June 26, 2008
ABR-AE-08000046

South Texas Project
Units 3 and 4
Docket Nos. 52-012 and 52-013
Response to Requests for Additional Information

Attached are responses to NRC staff questions included in Request for Additional Information (RAI) letter numbers 9, 10, 18, 34, 38, 39, 40, 41, 43, 45, 46, 47, 48, 49, 51 and 53 related to Combined License Application (COLA) Part 2, Tier 2 Sections 2.3S, 2.4S, 2.5S, 5.2, 9.1, and 11.4. This submittal includes responses to the following Question numbers:

FIGURE 1 Palacios Annual Wind Rose

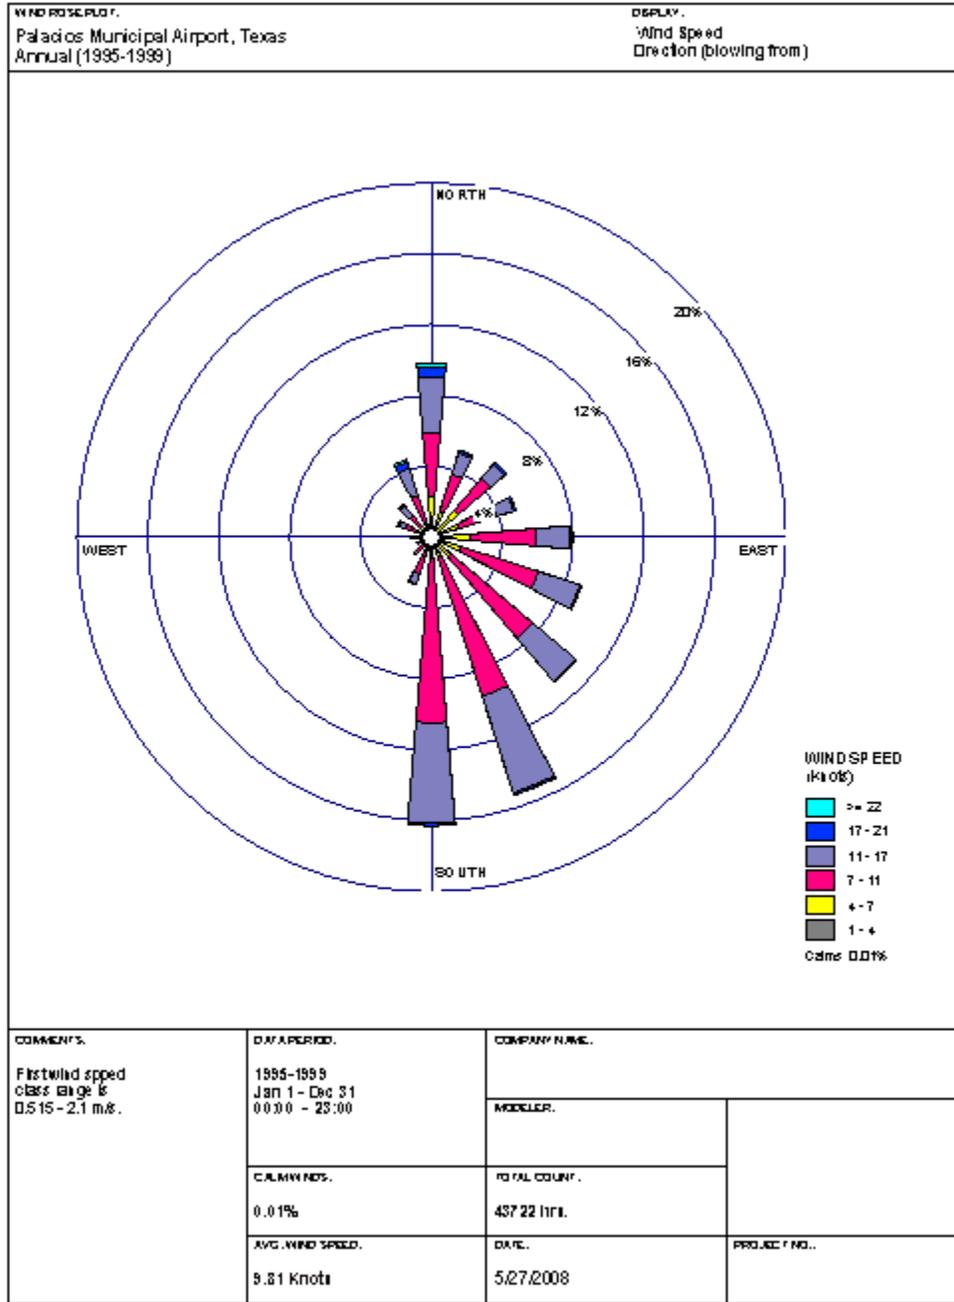
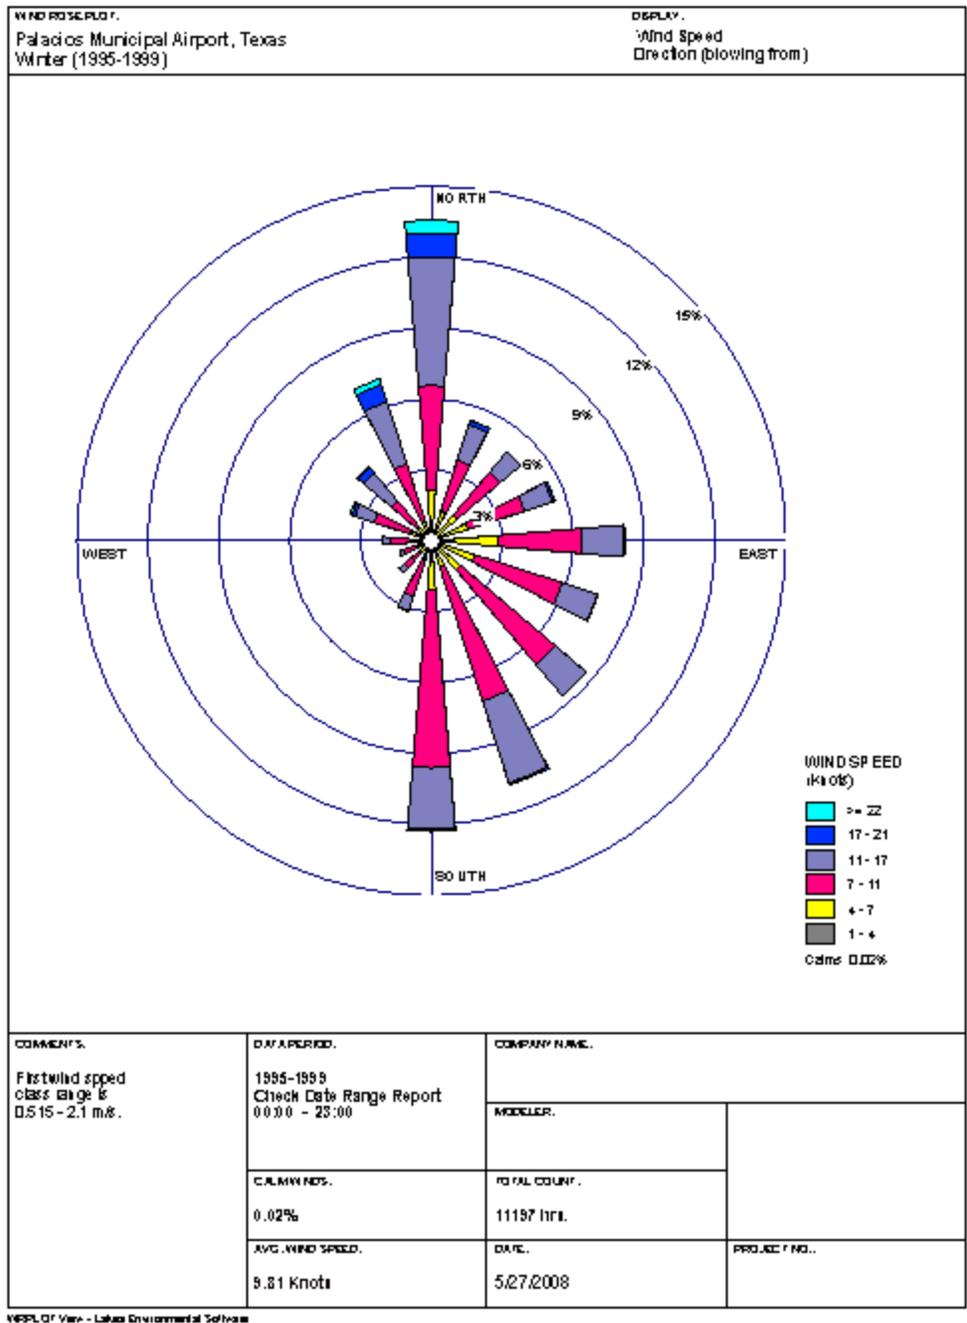
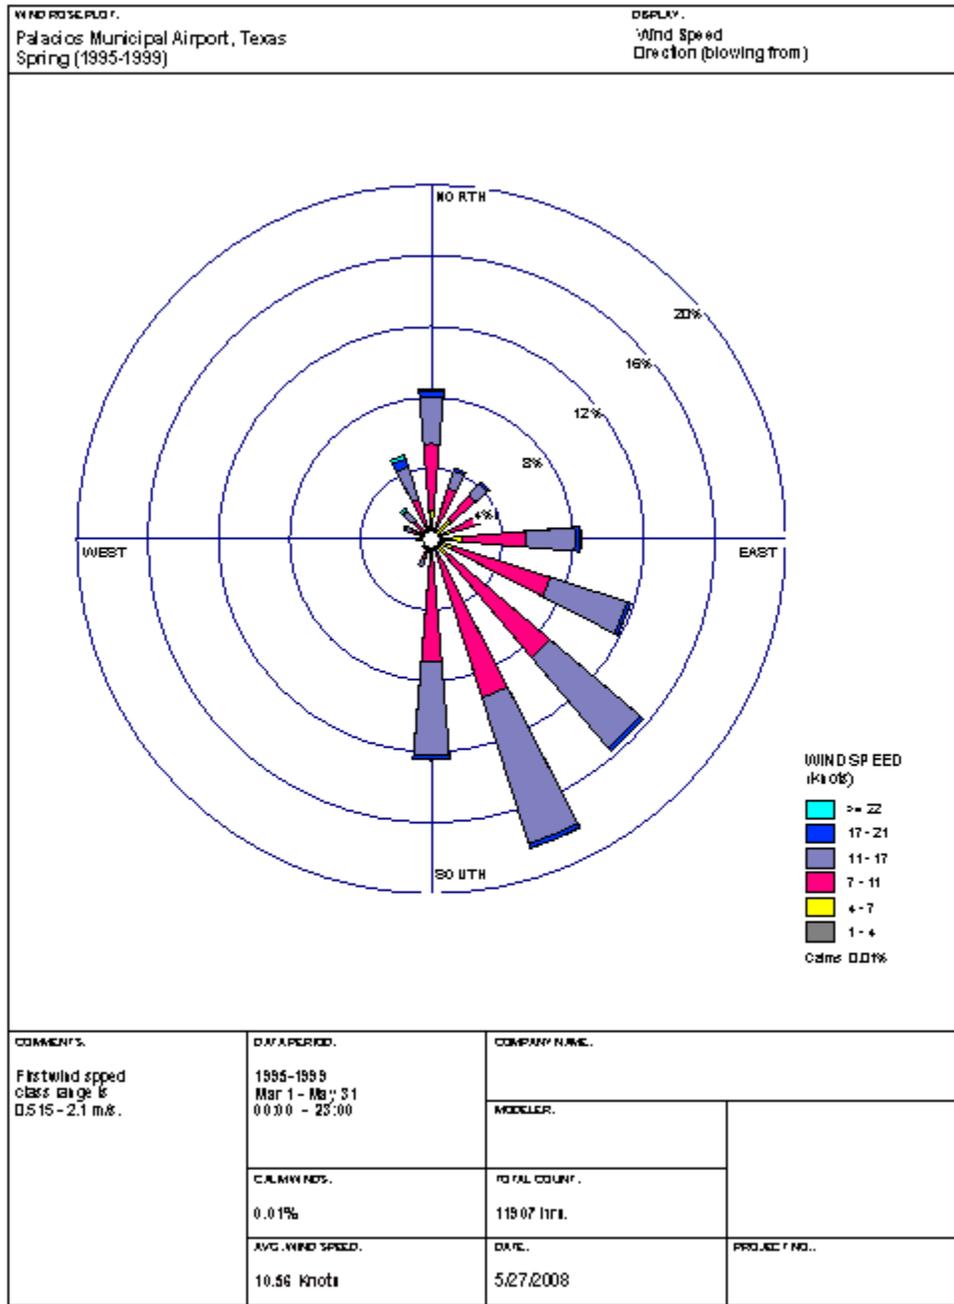
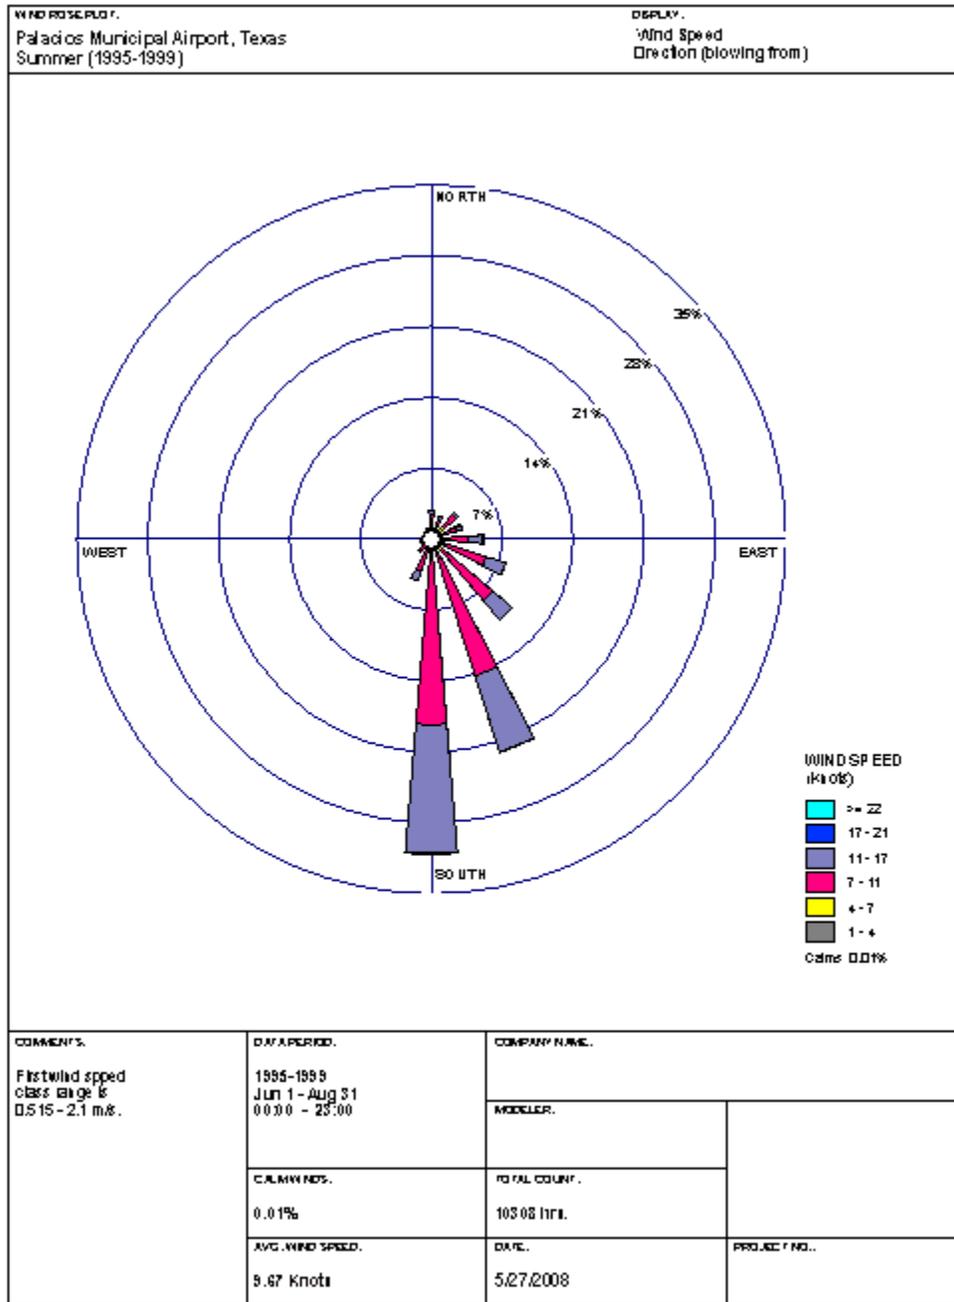
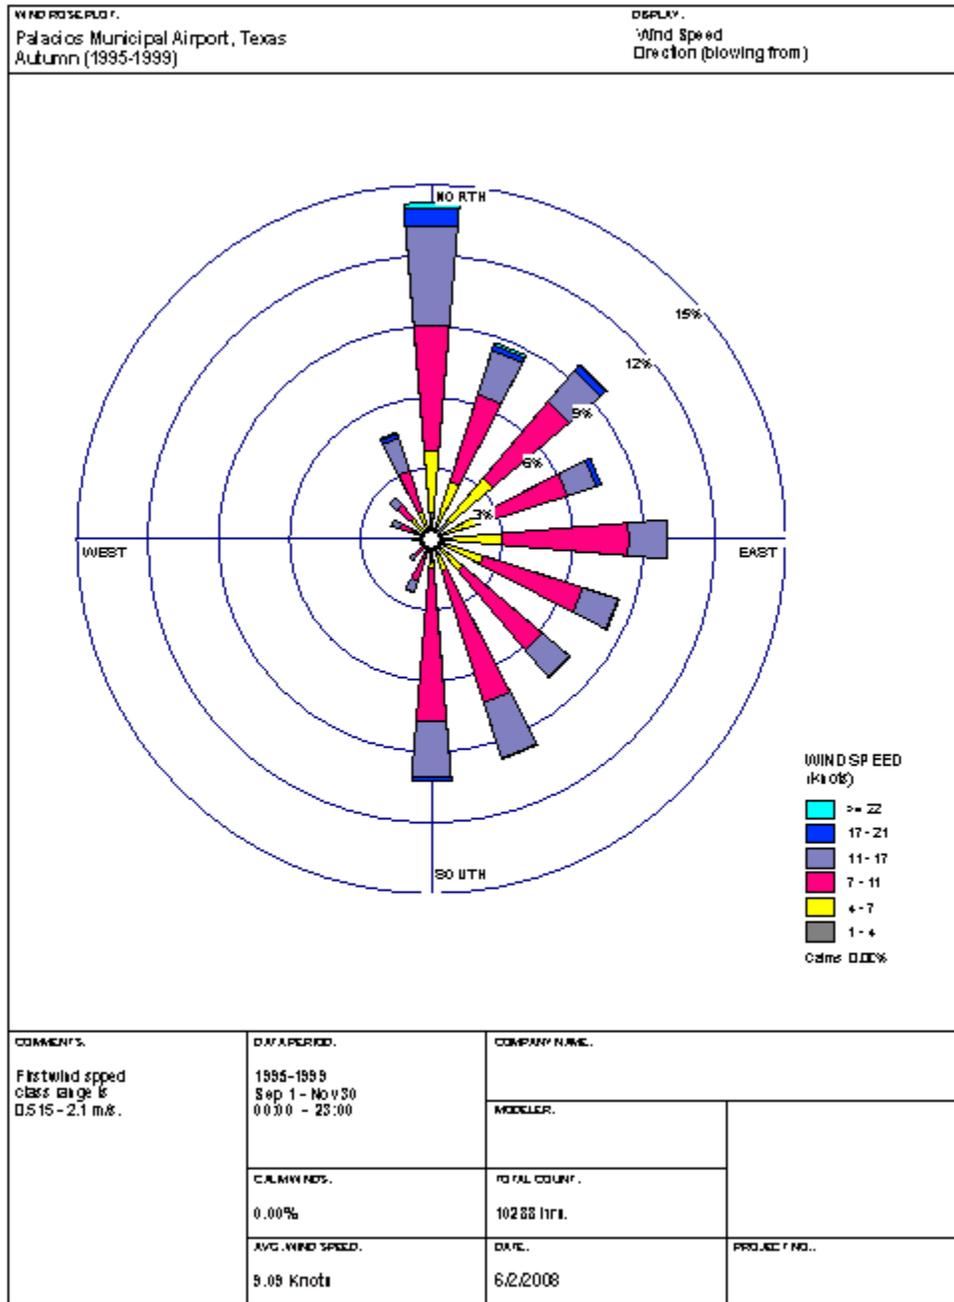
Question 02.03.02-4**QUESTION:**

(a) A 5-year period (i.e., 1995 through 1999) of wind measurements from the cooperative observing station at the Palacios Municipal Airport (Reference 1) has been evaluated. Longstanding U.S. EPA guidance has determined that for dispersion-related analyses, variations over a 5-year period of record are representative of longer duration data sets. Wind roses based on this data set for Palacios (Figures 1 through 5) show reasonably similar characteristics in predominant directions on an annual basis when compared to the onsite annual wind rose (see Figure 2.3S-2) (i.e., from the southeast through south sectors) and as indicated in the 2005 Local Climatological Data (LCD) summary for the Victoria National Weather Service (NWS) station (see Table 2.3S-2) (i.e., a prevailing direction of 160° or from the south-southeast sector).

Based on the 5-year period of record from 1995 through 1999, wind direction measurements from the cooperative observing station at the Palacios Municipal Airport (Reference 2.3S-27) show reasonably similar characteristics in predominant directions on an annual basis. At both locations, reasonably similar variations in the predominant wind direction sectors over the course of the year are also evident.
